HISTORIC AND DESIGN REVIEW COMMISSION

November 15, 2017

HDRC CASE NO: 2017-453
ADDRESS: 618 DAWSON ST NCB
LEGAL DESCRIPTION: 569 BLK 17 LOT 5
ZONING: RM-4, H
CITY COUNCIL DIST.: 2
DISTRICT: Dignowity Hill Historic District
APPLICANT: Dustin Brisco
OWNER: Fulco Properties, LLC
TYPE OF WORK: Exterior modifications, rehabilitation
APPLICATION RECEIVED: August 28, 2017
60-DAY REVIEW: October 27, 2017
POSTPONED BY APPLICANT: November 26, 2017

Build New Deck over concrete

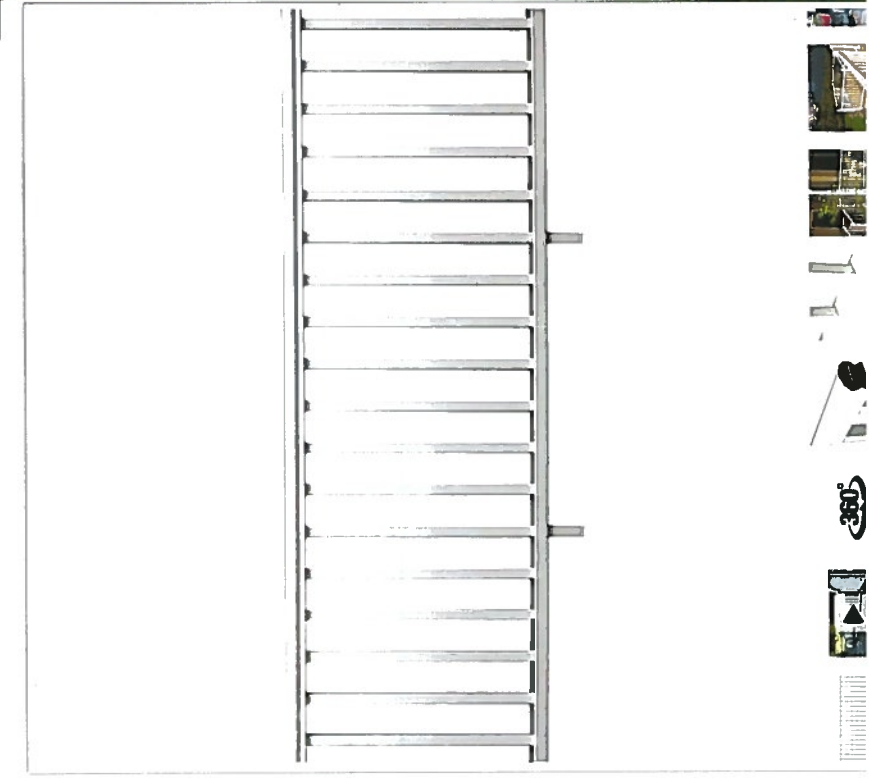
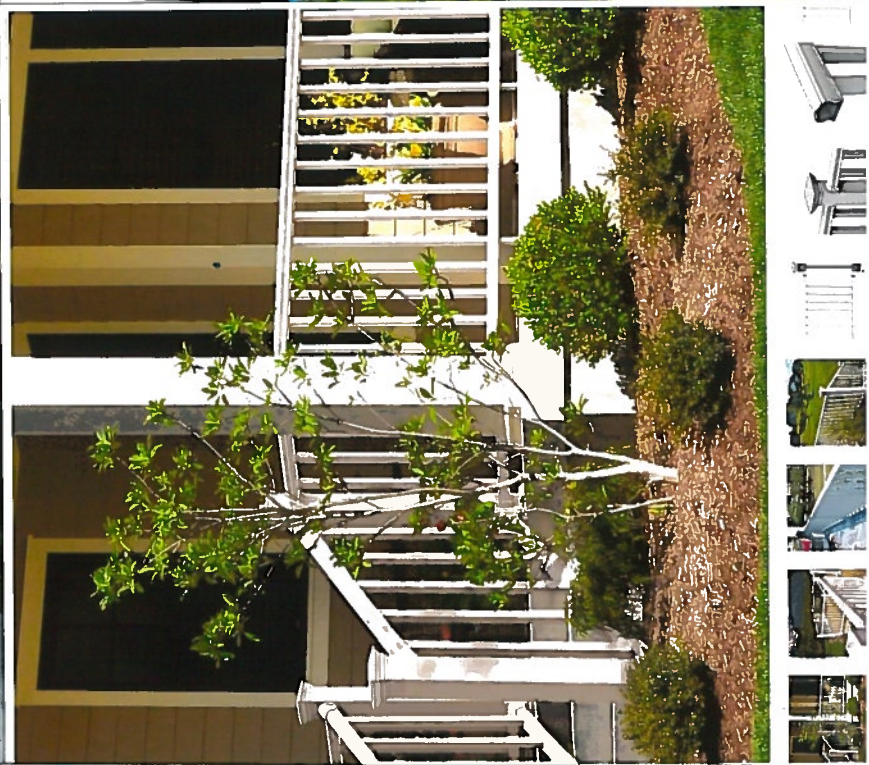
- d. PORCH – The applicant has proposed to install a new wood deck over the existing front porch concrete slabs and steps. The existing concrete porch has begun separating from the concrete foundation of the historic structure and is uneven in respect to the front doorway. The proposed deck would level the front porch to the front door, approximately 3 feet from grade. The deck would be constructed with 2x6 treated and stained lumber and feature 3 feet tall railing, wood steps, and wood skirting. Staff finds the proposed porch modifications consistent with the Guidelines for Exterior Maintenance and Alterations 2.7.B.i through v.

Staff recommends approval of window replacement and wood porch installation based on findings b through c. Staff reiterates the following window specifications: The proposed window should feature meeting rails that are no taller than 1.15" and stiles no wider than 2.25". There should be a minimum of two inches in depth between the front face of the window trim and the front face of the top window sash. This must be accomplished by recessing the window sufficiently within the opening or with the installation of additional trim to add thickness. Window trim must feature traditional dimensions and an architecturally appropriate sill detail. Window track components must be painted to match the window trim or concealed by a wood window screen set within the opening.
